BEFORE THE WASHINGTON UTILITIES AND TRANSPORTATION COMMISSION

| In the Matter of PacifiCorp's Final Clean Energy Implementation Plan | DOCKET UE-210829 |

COMMISSION STAFF COMMENTS REGARDING
PACIFICORP'S FINAL CLEAN ENERGY IMPLEMENTATION PLAN
SUBMITTED IN COMPLIANCE WITH
CHAPTER 19.405 RCW and WACs 480-100-640 through -665
<AND UNDER CONSOLIDATED DOCKETS UE-191023 AND UE-190698, Order R-601>

May 6, 2022

Figure 1: 2022-2045 Interim Targets⁶

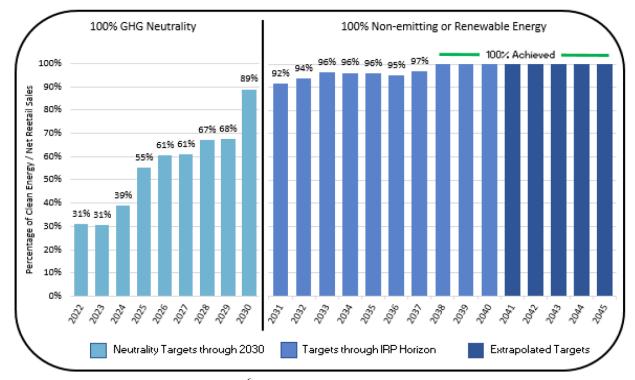
PacifiCorp's CEIP lists a series of interim targets that get it to 55 percent clean energy by 2025, and 89 percent by 2030. This is shown in Figure 1 below.

As discussed in Staff's comments on PacifiCorp's draft CEIP and once again highlighted in these final CEIP Staff comments, PacifiCorp's modeling continues to fall short beyond the Company's treatment of the SCGHGs. A disconnect remains between PacifiCorp's modeling of its interim targets between 2021 through 2040 and how the Company calculates its target setting during the final five-year period (i.e., 2041 to 2045). The linkages between PacifiCorp's 2021 IRP portfolio development and its interim target setting through 2040 are clear. 32 However, PacifiCorp's 2021 IRP only covers the 2021-2040 twenty-year time horizon. The Company's final CEIP workpapers demonstrate that PacifiCorp only applied a linear interpolation of its 2021 IRP preferred portfolio to calculate its 2041-2045 targets. The Company, in fact, offers two sets of targets: one based on extrapolating over the 2030-2040 ten-year period of PacifiCorp's 2021 IRP time horizon; and a second, higher set of targets extrapolated over the entire 2021-2040 time horizon.³³ Staff observed no attempt by PacifiCorp to optimize these linearly extrapolated results to achieve a lowest reasonable cost solution, as required per rule.³⁴ PacifiCorp's decision to optimize a resource portfolio through 2040 and not 2045 stands in marked contrast to the modeling decisions and underlying analytics that inform both Avista Corporation's 35 (Avista) and Puget Sound Energy's ³⁶ (PSE) CEIP interim target setting.
